# THE CARRIAGE HOUSE

HISTORIC DISTRICT COMMISSION // MAY 22, 2020

## SUMMARY OF REVISIONS SINCE HDC APPROVAL

# BUILDING AXON VIEW // DESIGN REVISIONS

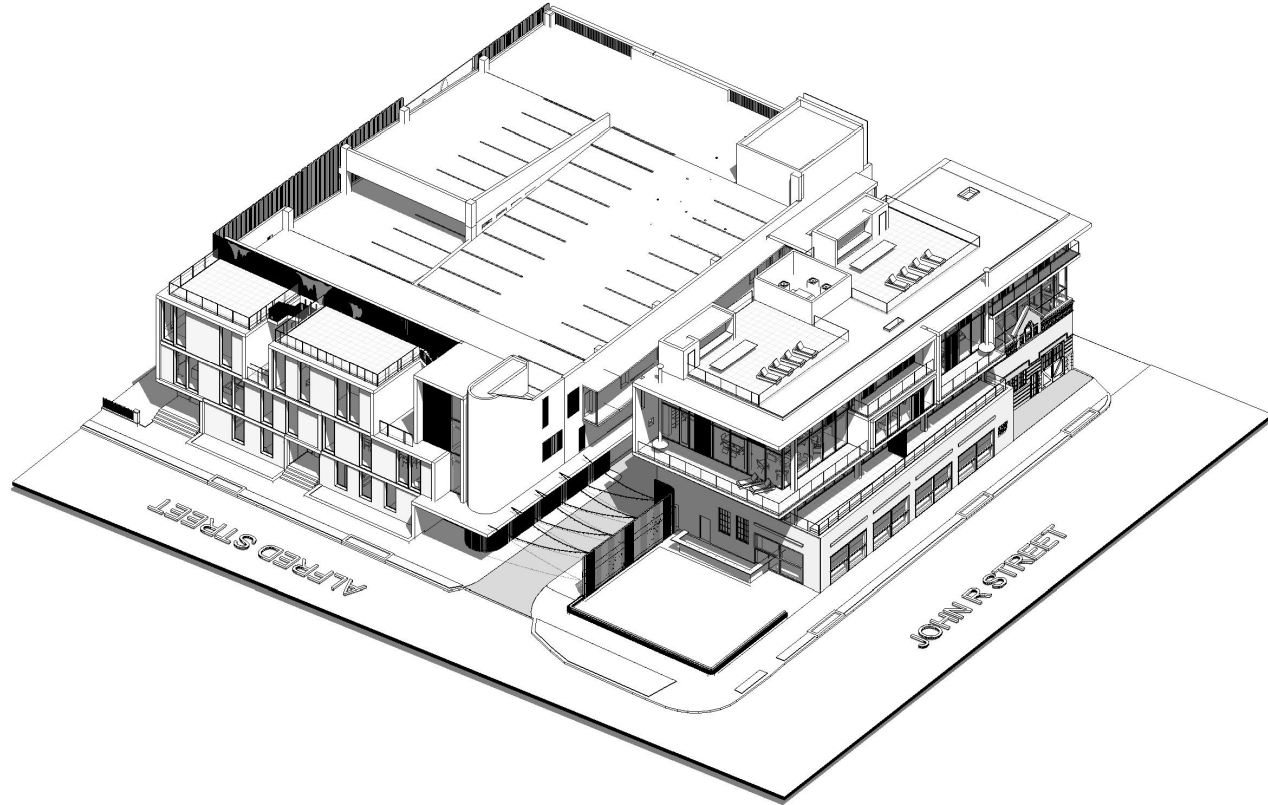
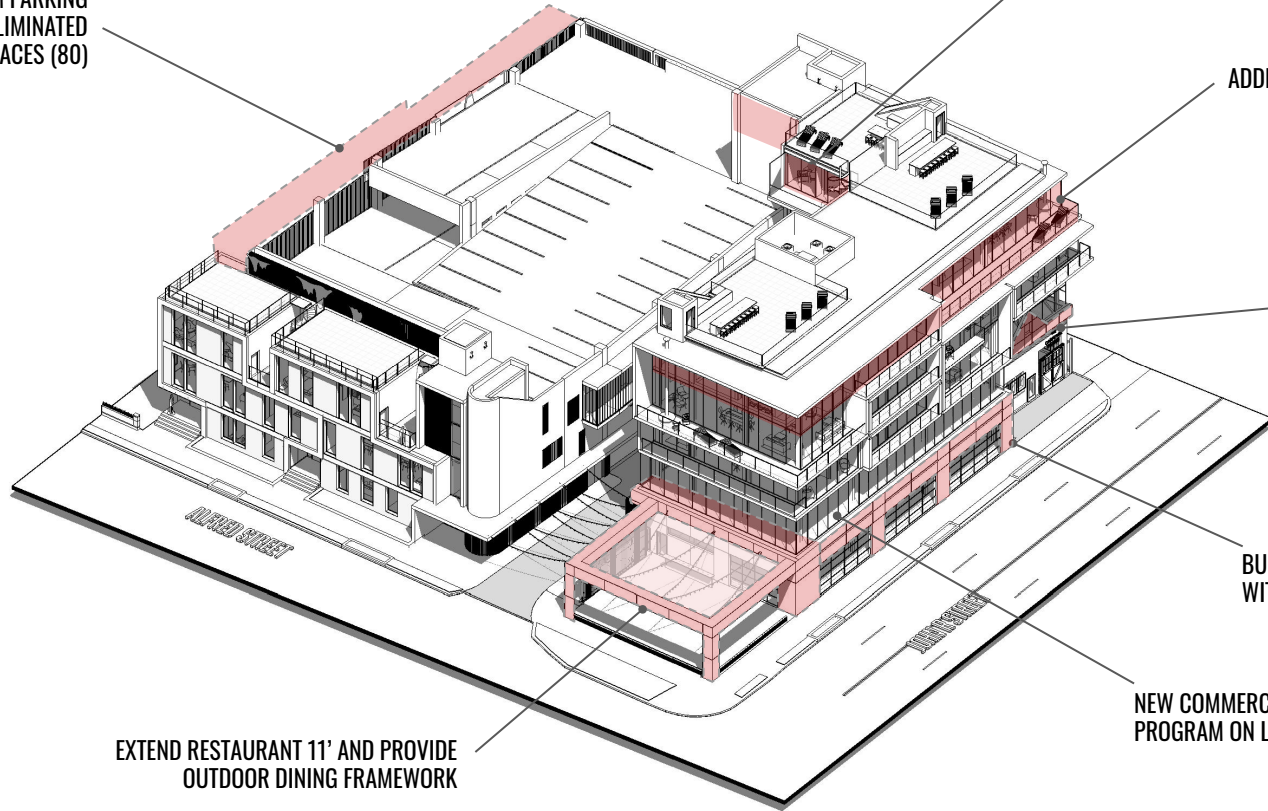
REMOVED 12' FROM PARKING  
STRUCTURE AND ELIMINATED  
12 SPACES (80)

ADDED RESIDENTIAL SPACE  
AND EXTENDED ELEVATOR

ADDED 5TH STORY

BUILD NEW GABLE ON  
CARRIAGE HOUSE

BUILD NEW ONE STORY STRUCTURE  
WITH SIMILAR FOOTPRINT

NEW COMMERCIAL OFFICE  
PROGRAM ON LEVEL 2

EXTEND RESTAURANT 11' AND PROVIDE  
OUTDOOR DINING FRAMEWORK

DIMENSIONED PLAN // DESIGN REVISIONS

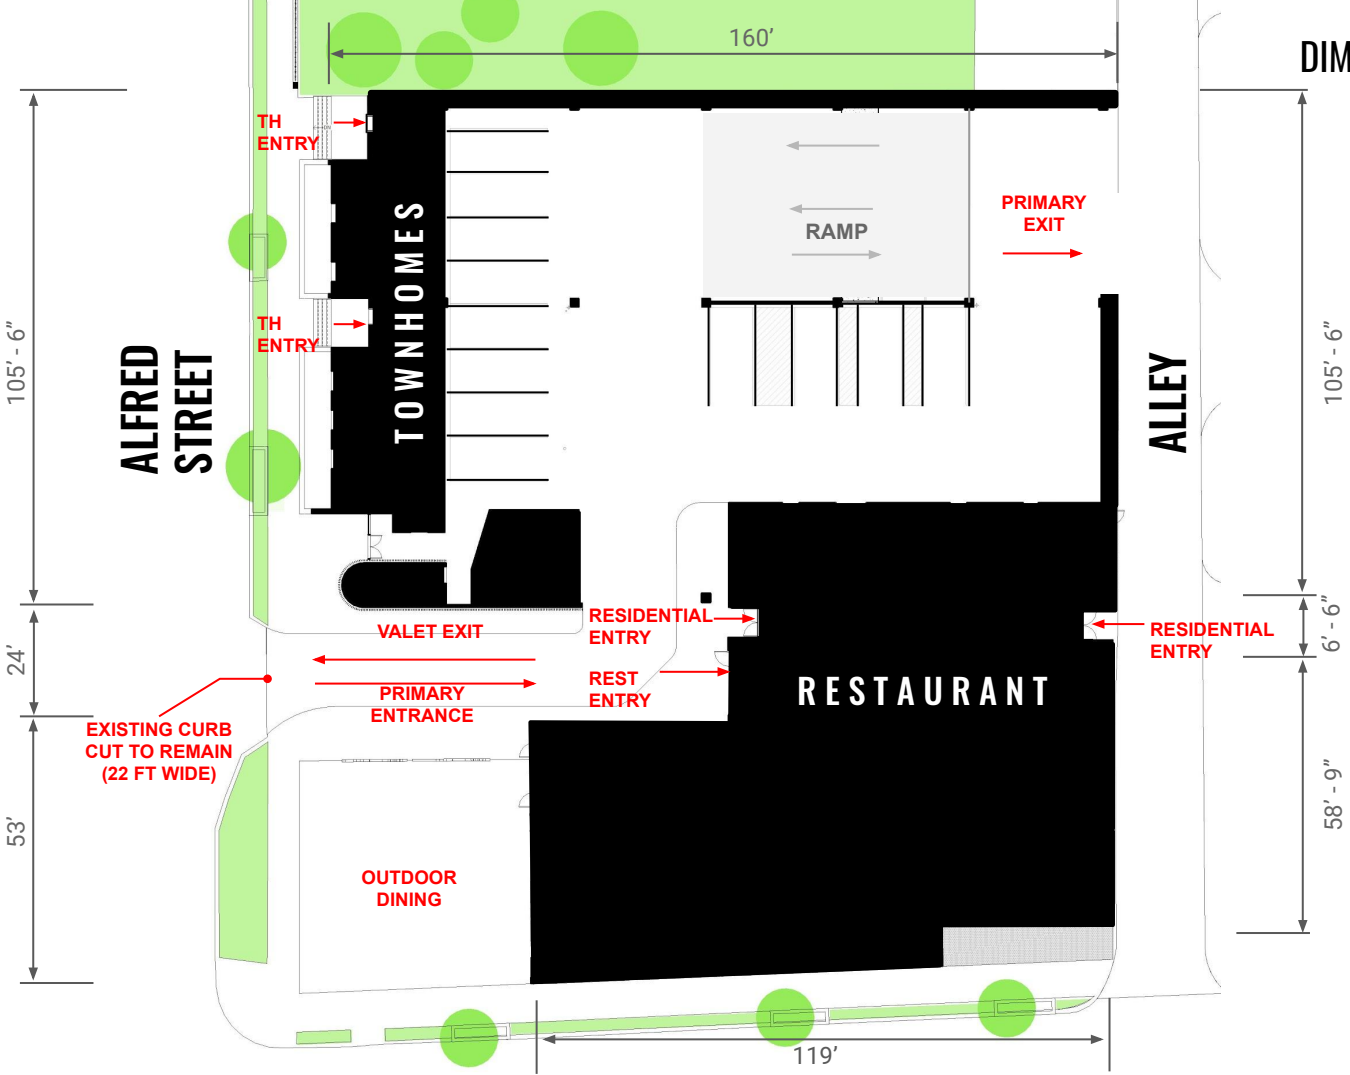
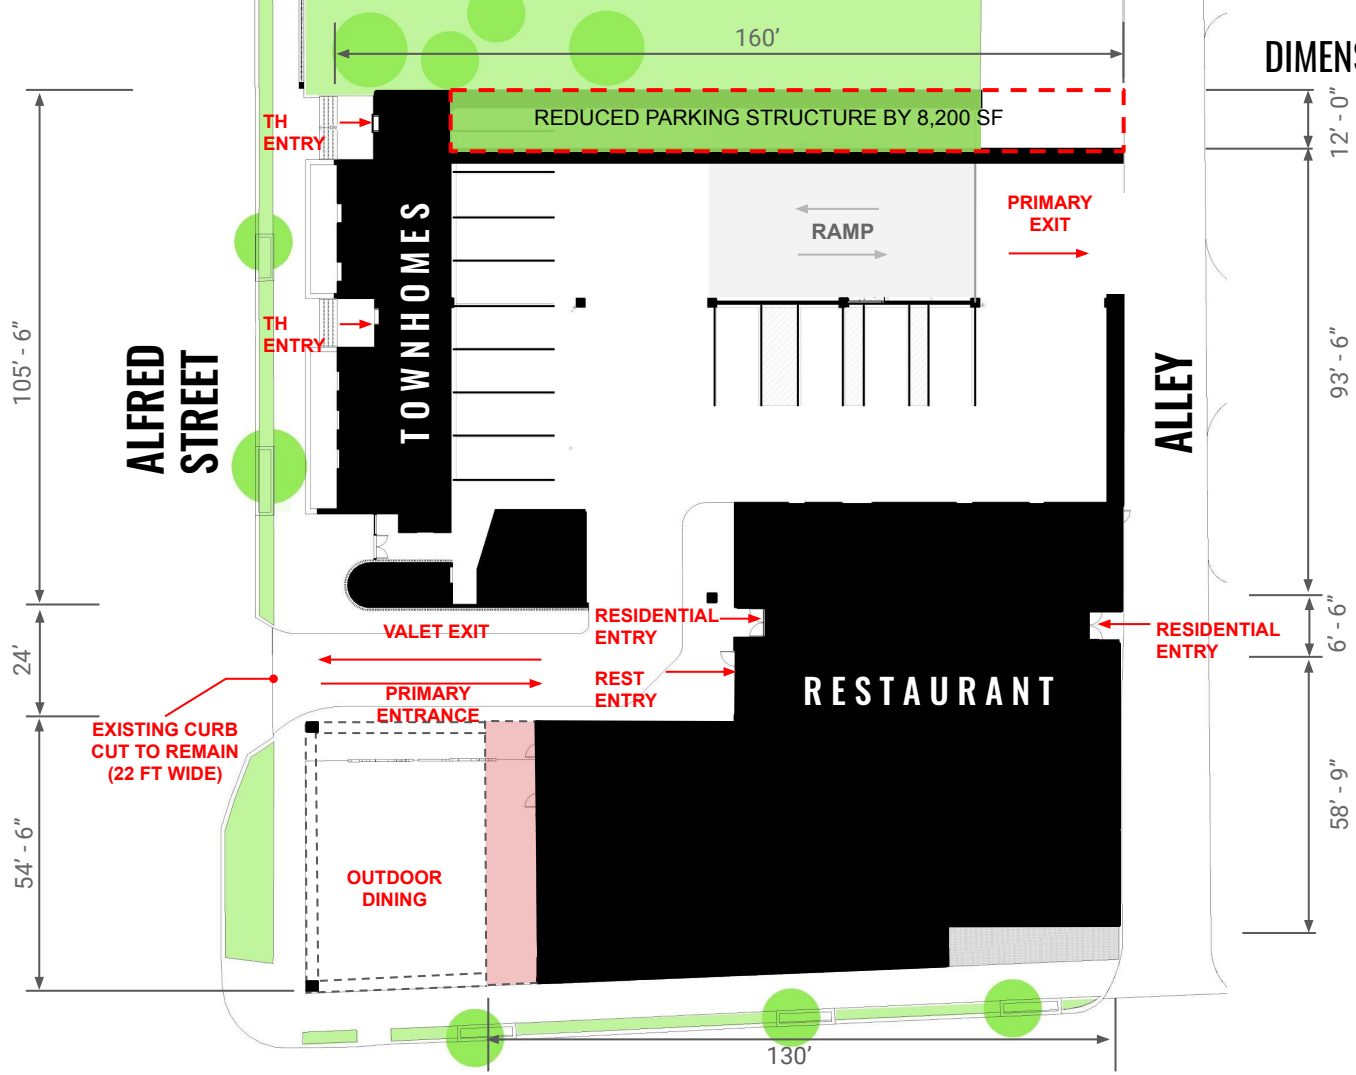
- ADDED A FLOOR FOR 3 ADDITIONAL RESIDENTIAL UNITS (LEVEL 5) AND A COMMERCIAL USE (LEVEL 2)
- REPLACE FAILING ONE STORY BUILDING WITH NEW STRUCTURE
- BUILD NEW GABLE STRUCTURE ON CARRIAGE HOUSE WHERE A PORTION HAS COLLAPSED
- EXTEND RESTAURANT 11 FEET TO THE SOUTH AND NEW FRAMEWORK STRUCTURE AT OUTDOOR DINING AREA
